TITLE : AIR CONDITIONING – AVIONICS EQUIPMENT VENTILATION – ADD RESISTOR ON AEVC
INLET SKIN AIR VALVE CONTROL LINE.

SERVICE BULLETIN No. : A320-21-1129

REVISION No. : 01 – Mar 06/02

SERVICE BULLETIN REVISION TRANSMITTAL SHEET

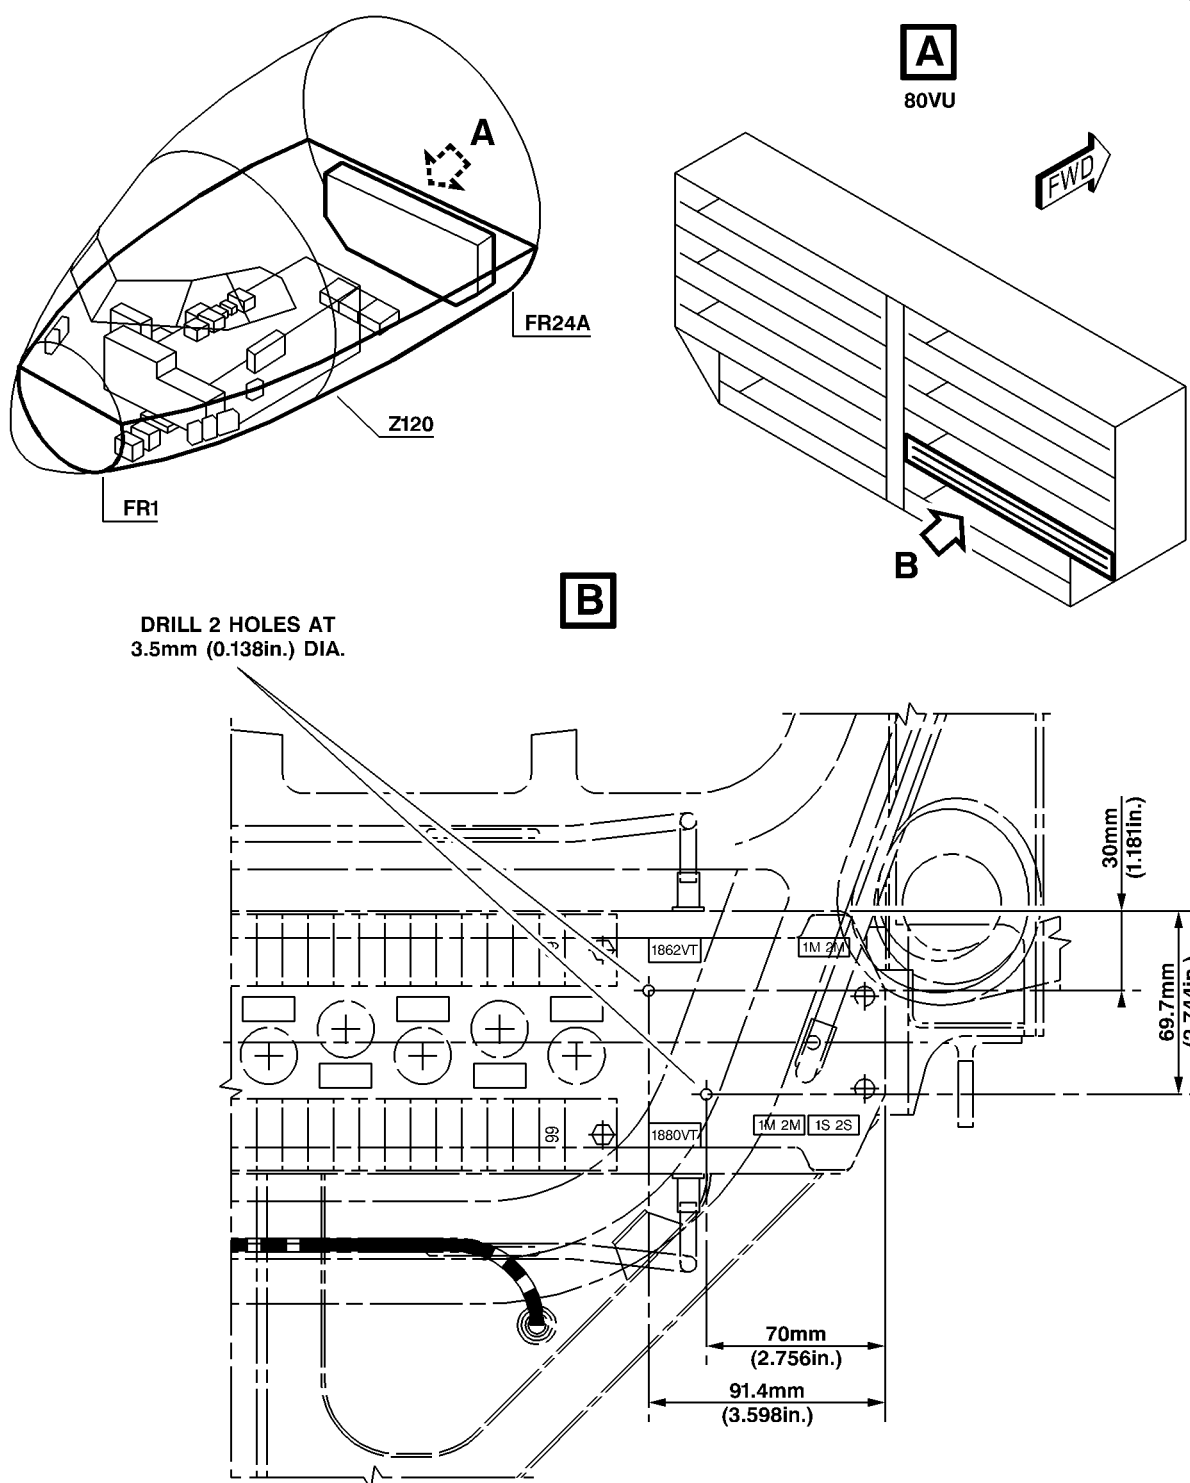
- (1) Modify the rear plate of the shelf 86VU.
Refer to figure 1

(a) Drill two holes to 3.5 mm (0.138in.) dia., at the dimension given in the figure.

Figure 2 Sheet 1
Installation of the Resistor Assy in the Shelf 86VU

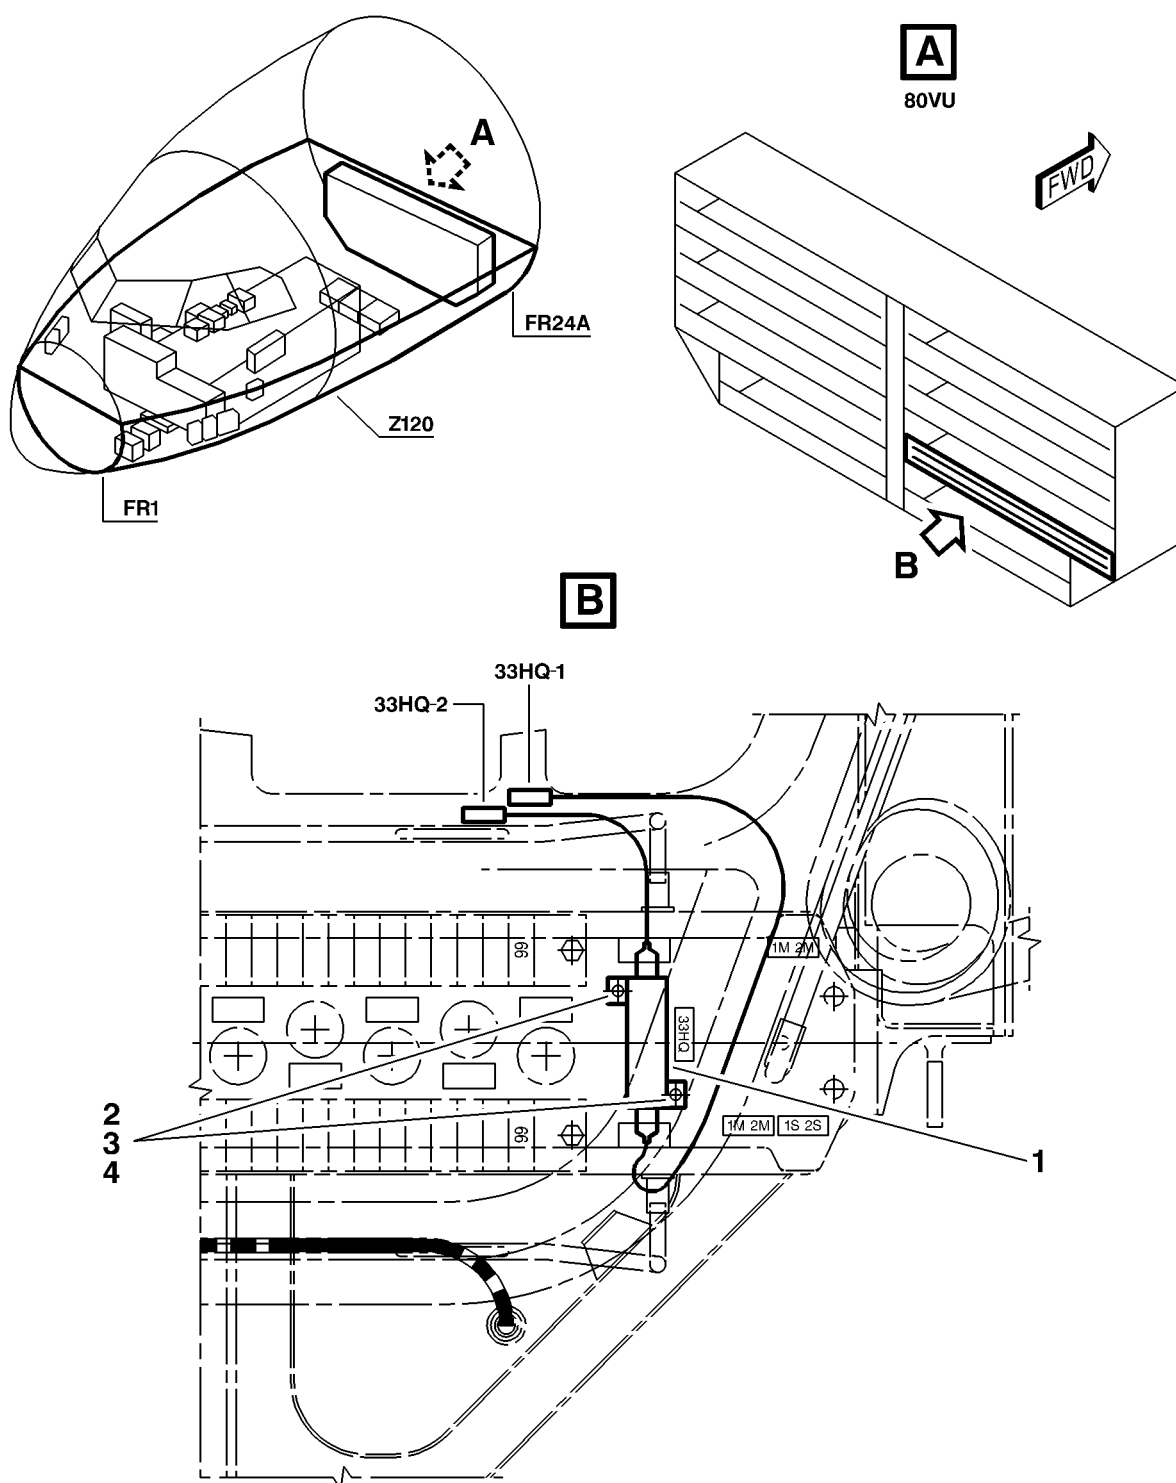
- (2) Install a resistor on the rear plate of the shelf 86VU.
Refer to figure 2

(a) Near the 1862VT and 1880VT, Install :

(b) Near the resistor, bond the placard 33HQ, supplied in :

Figure 3 Sheet 1
Modification of the Wiring in the Shelf 86VU

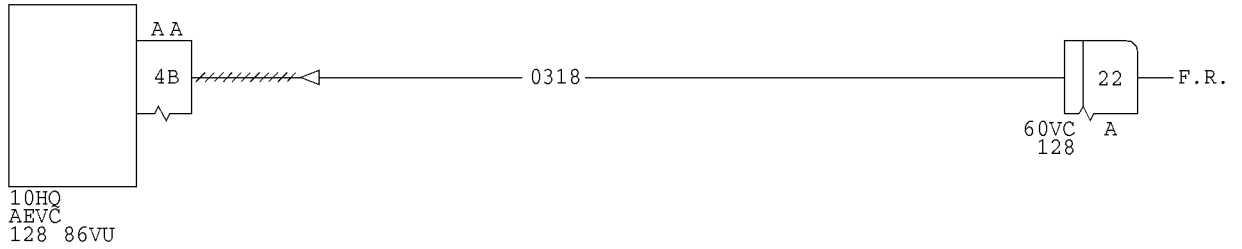
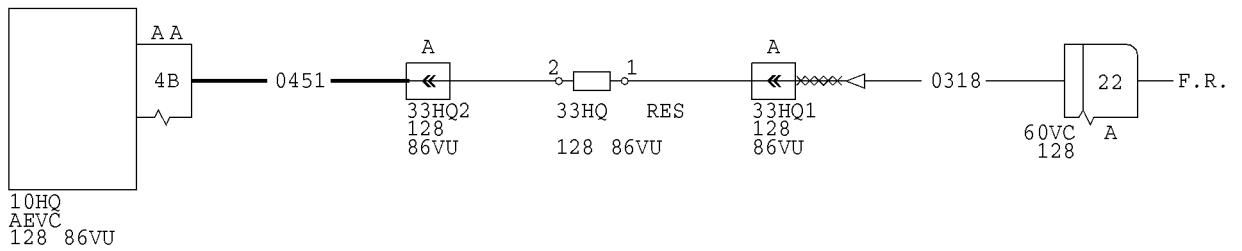
- (3) Modify the wiring in the shelf 86VU.
Refer to figure 3
Refer to figure 4

(b) Modify the connection of wire shown on the lines 1 and 2
(Refer to figure 4).

(c) Install the wire shown on the line 6 (Refer to figure 4)
supplied in :
